P 27771
A _____

SEWAGE DISPOSAL SYSTEM

MARYLAND STATE DEPARTMENT OF HEALTH*

SUBDIVISION _____ ROAD 10194 Baltimore National LOT _____
Pike

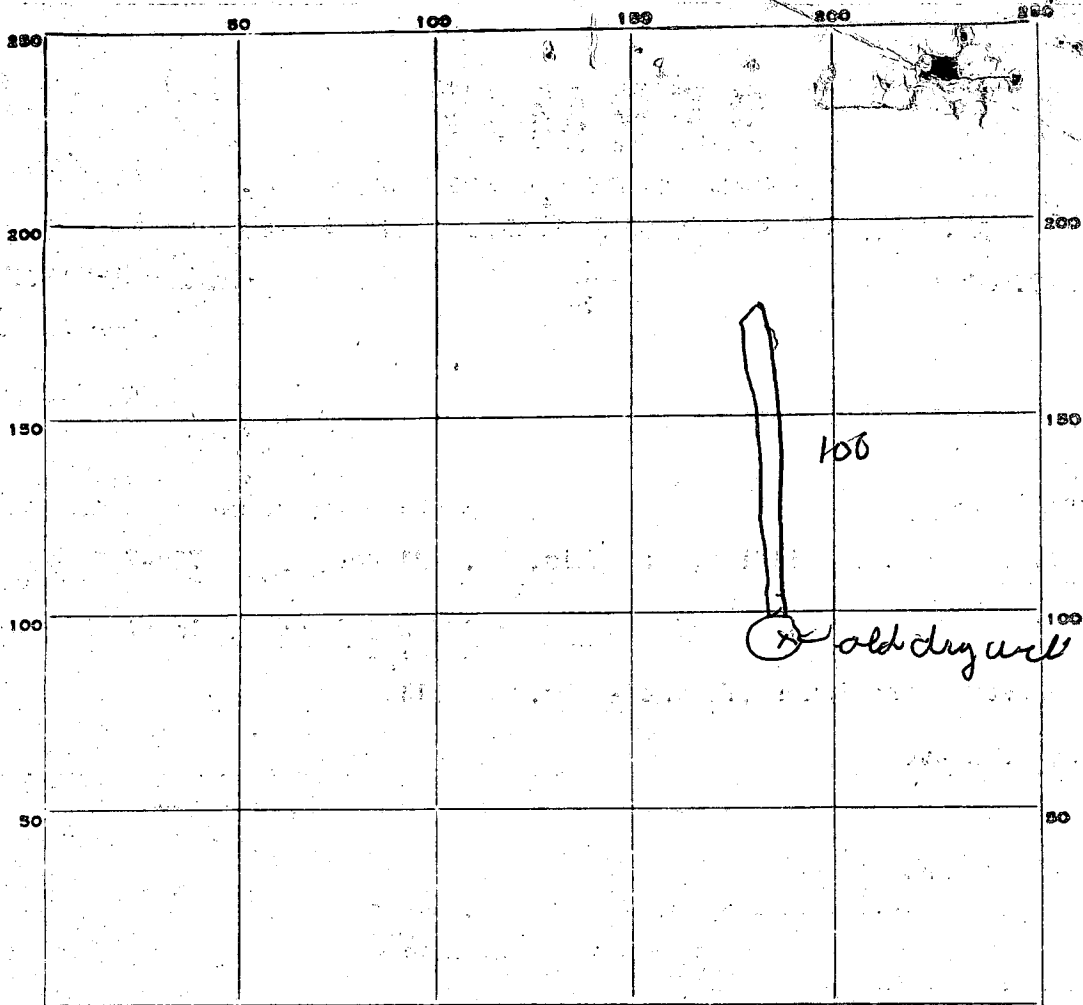
- floor drain to be taken off septic tank

Trench 100' long - 11 1/2' deep - 8' stone trench to come off

SW - follow contour of ground & be inspected before gravel is installed

Wash machines to go thru tank. floor drain not to be used.

8-28-78
REMARKS gravel to extend 4' below grade - OK to gravel trench

Flood drain & wash machine into separate pit
